Product Change Notification: PCN-22-143739

General Product Description: (Text limited to 120 characters)
Terminal Contacts

Paper reel change from 999225-1 to 2400473-1

Paper reel appearance status 999225-1 & 2400473-1

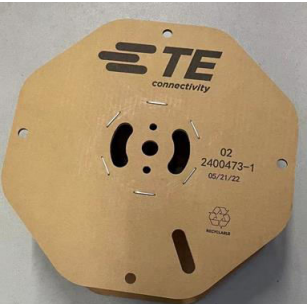
Reel part	Reel status	Fixed method	Different
995225-1	 		<ol style="list-style-type: none"> 1. No hole 2. Fixed of FIBER TAPE

1. Paper core status is different
2. Fixed method is different
3. Flag have small change, two side the circular hole change to the rectangle hole

Reel part	Reel status	Fixed method	Different
2400473-1	 		<ol style="list-style-type: none"> 1. Hole on the core 2. Fixed of core hole
